United Nations ECE/TRANS/WP.29/GRSP/2015/10

Fifty-seventh session
Geneva, 18-22 May 2015
Item 16 of the provisional agenda
Collective amendments to Regulations Nos. 14 and 16

Proposal for Supplement 7 to the 06 series of amendments to Regulation No. 14 and Supplement 6 to the 06 series of amendments to Regulation No. 16

Submitted by the expert from the Netherlands*

***Source*: this figure was in doc. GRSP-50-23 tabled by the expert from Germany.**

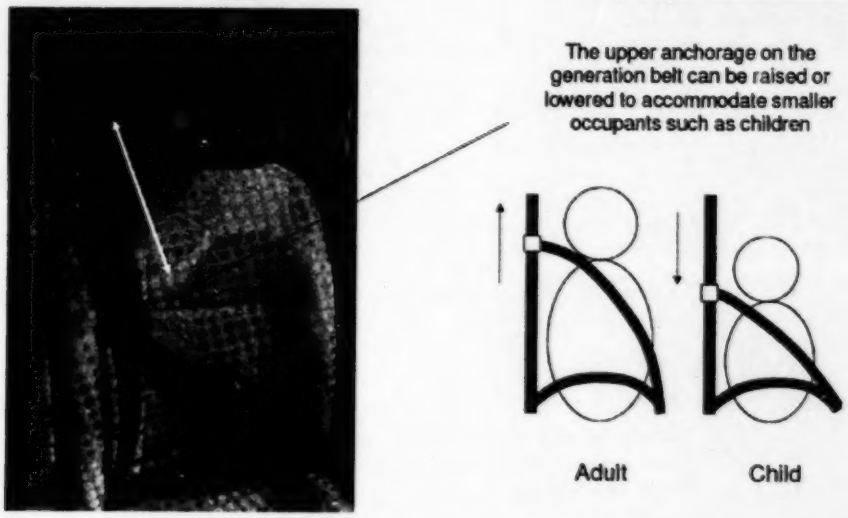
2. The situation explained above has caused confusion so far: a belt/restraint system that makes use of **a flexible shoulder adjustment device for height** (sometimes called **generation belt,** see the explaining figure on next page), does not make use of the upper-pillar loop for adjustment and therefore cannot be mentioned on the Communication form.

5. Moreover, the complexity and sensibility of the flexible adjustment device for height (generation belts) does not justify a dynamic test according to UN Regulation No. 16, which provides a generic stiff seat. A test proposal for a restraint system (in combination with a real vehicle seat) is shown below:
